**UNITED STATES OF AMERICA
NUCLEAR REGULATORY COMMISSION**

Docket No. 70-3103

Louisiana Energy Services, L.P.
National Enrichment Facility

**DIRECT TESTIMONY OF GEORGE RICE
ON BEHALF OF NUCLEAR INFORMATION AND RESOURCE SERVICE
AND
PUBLIC CITIZEN**

Figure 1
Schematic - Geologic Cross Section in Vicinity of Proposed Site

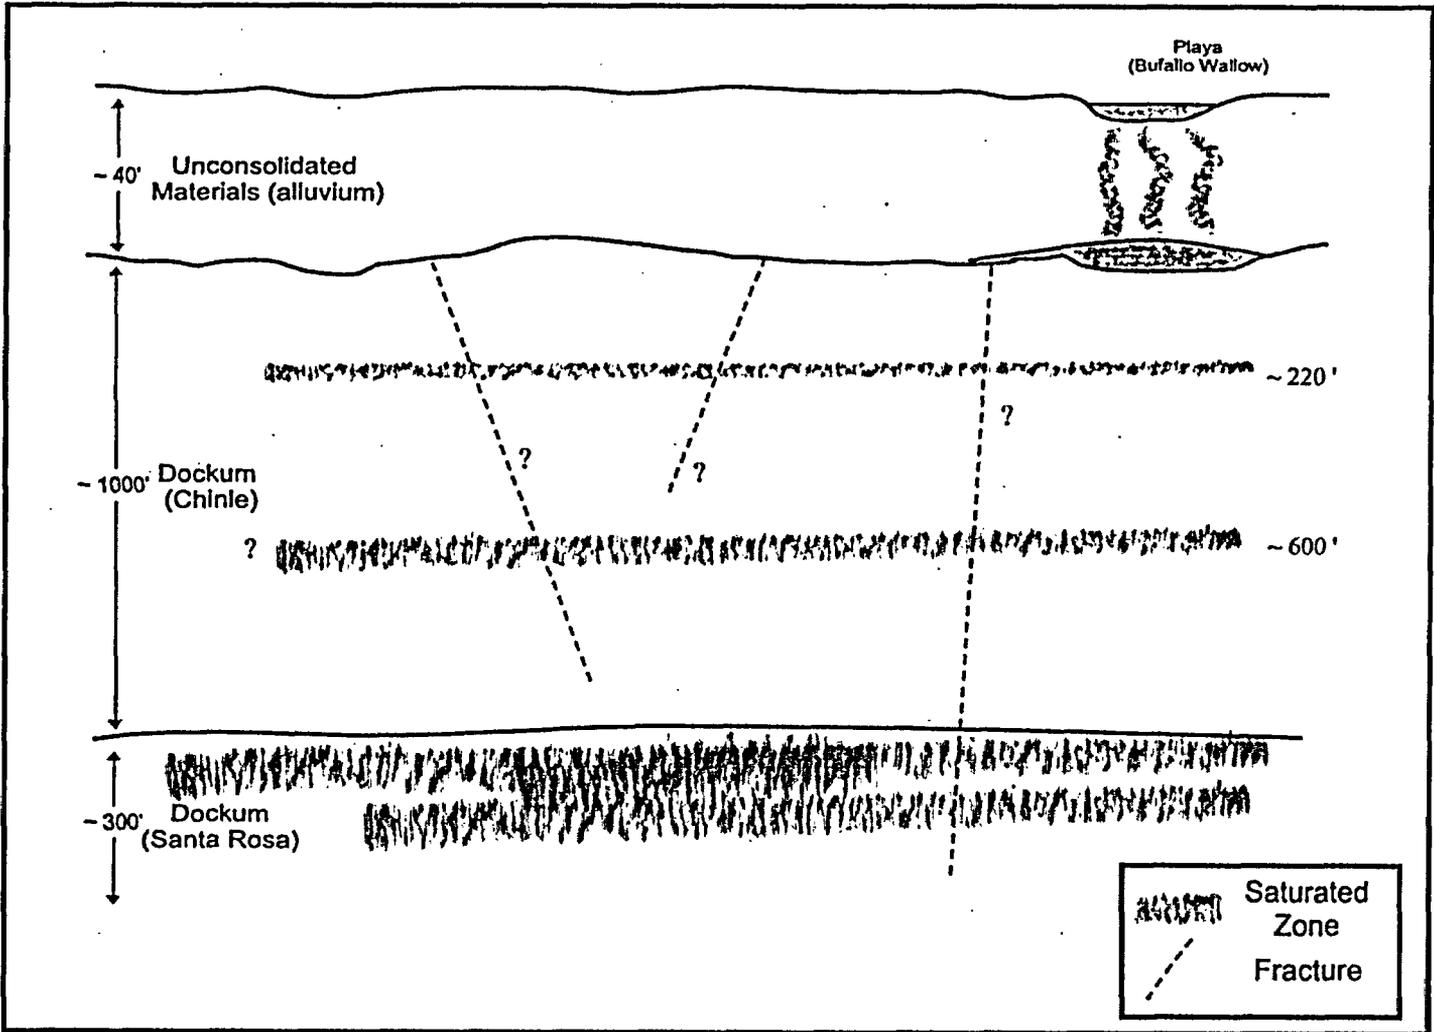
A schematic geologic cross-section is shown in figure 1, accompanying this testimony. The question marks in the figure indicate uncertainty regarding existence of fractures and the water-bearing zone at 600 feet.

Figure 3
Schematic - Geologic Cross Section in Vicinity of Proposed Site

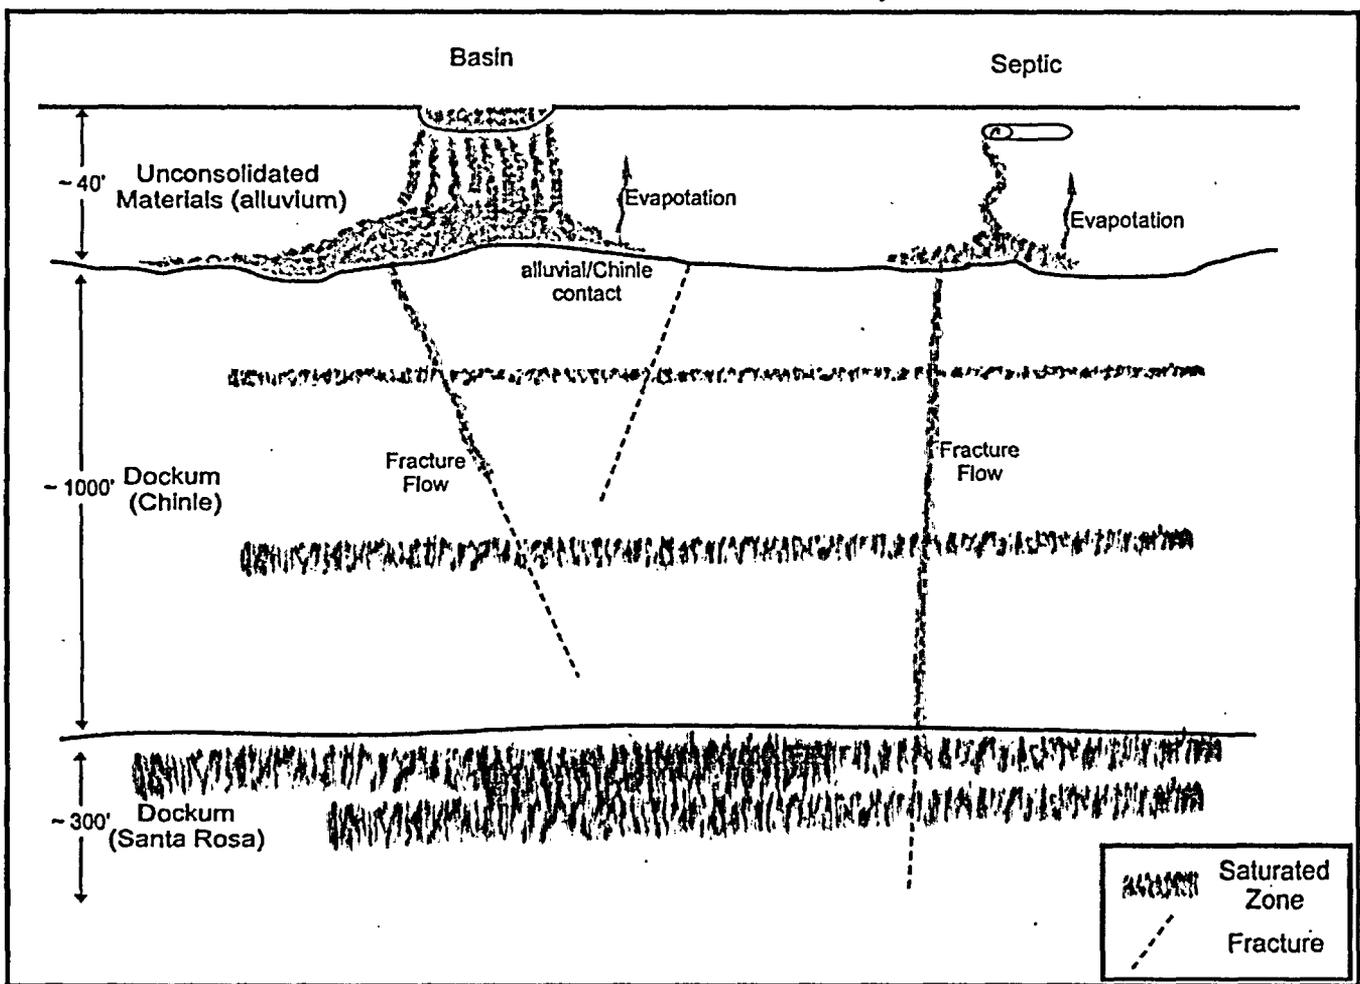
Figure 3 is a schematic cross-section depicting subsurface discharge from the stormwater basin and a septic field.
